## ADDENDUM

**PROJECT:** Dodge County, Department of Roads  
New Maintenance Facility  
Fremont, Nebraska

AD-2

**DATE ISSUED:** Wednesday, March 25, 2015

Drawing Title Drawing Title and Subtitle	
From Sheet: C-101	for CA use:
Drawing # C-101.1

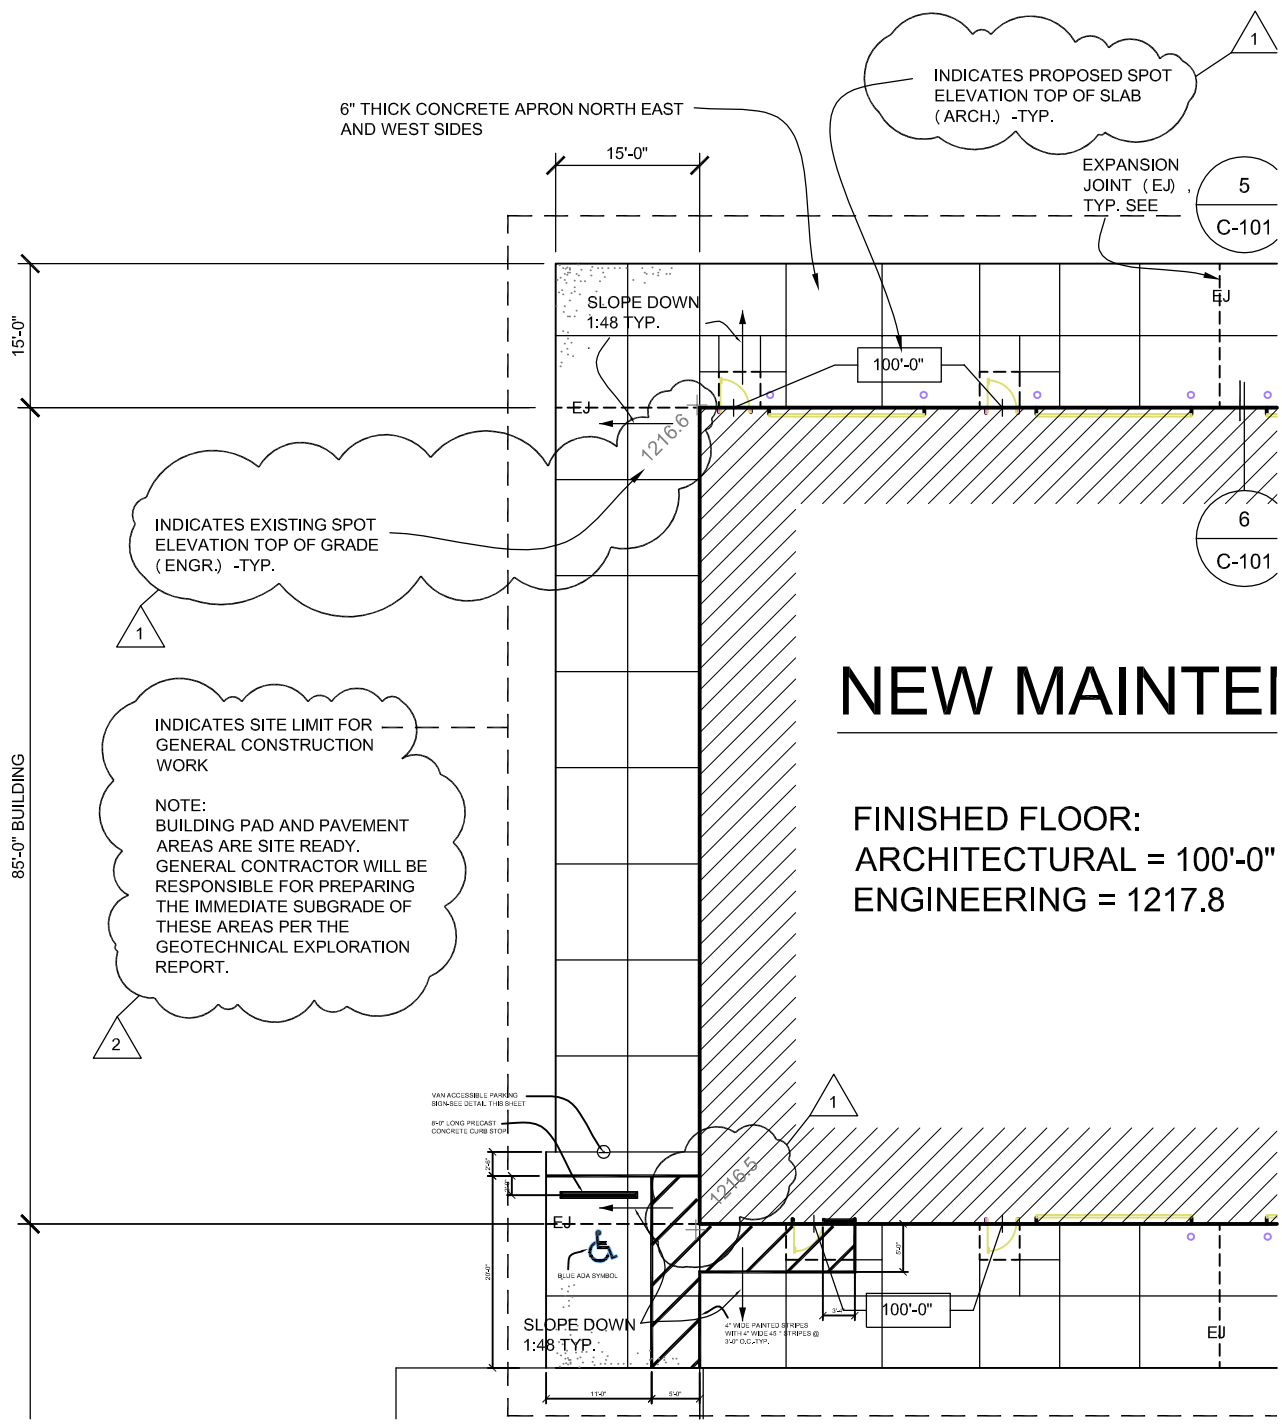
**In reference to Sheet C-101**, on the Site Plan revise the note related to site limit for general construction work as indicated on attached Supplemental Drawing C-101.1 and add the following:

"Note: Building pad and pavement areas are site ready. General contractor will be responsible for preparing the immediate sub-grade of these areas per the Geotechnical Exploration Report."

NOTE:  
BUILDING PAD AND PAVEMENT AREAS ARE SITE READY. GENERAL CONTRACTOR WILL BE RESPONSIBLE FOR PREPARING THE IMMEDIATE SUBGRADE OF THESE AREAS PER THE GEOTECHNICAL EXPLORATION REPORT.
